SUMMARY

Attached you will find calculations done by a structural engineer indicating that the steel reinforcement, in the long walls of the screen treatment structure constructed as part of the Arboretum Pond 3 reconstruction, is insufficient.

Static active pressure distribution

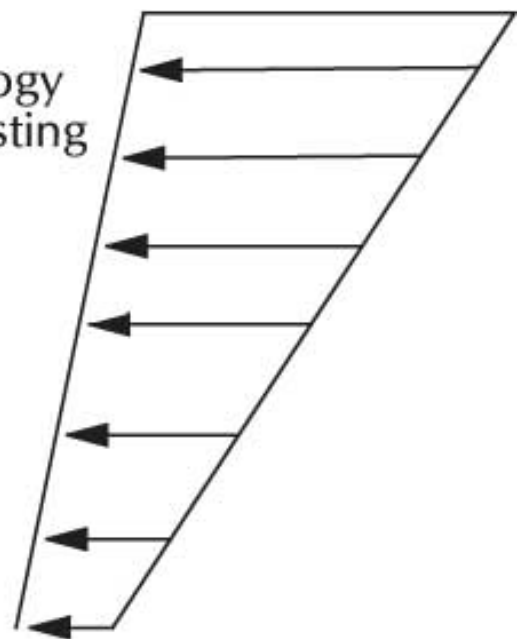
No design calculations could be found in the file for review purposes but based on the physical evidence and the calculations done by our consultant and given the knowledge base of the designer it is my opinion that several issues occurred resulting in this failure.

- 1) The designer was not a structural engineer. Most of our sewer structures are relatively small and the calculations associated with them are relatively simple. This allows a relatively routine design to be used that is in fact included in our standard specifications. This design fell well outside the design parameters for those standards.
- 2) The design and reinforcement were modified by the design engineer but it would appear that the overburden load (from our vactors driving close to the wall to remove sediment) was ignored – see load sketch below.
- 3) The insufficient tensile reinforcement of the concrete combined with fact that roof was not included (as is the case with most of our structures) to pin the walls in place resulted in failure (defined as excessive deflection) when the walls were stressed with load from vactors during maintenance operations.
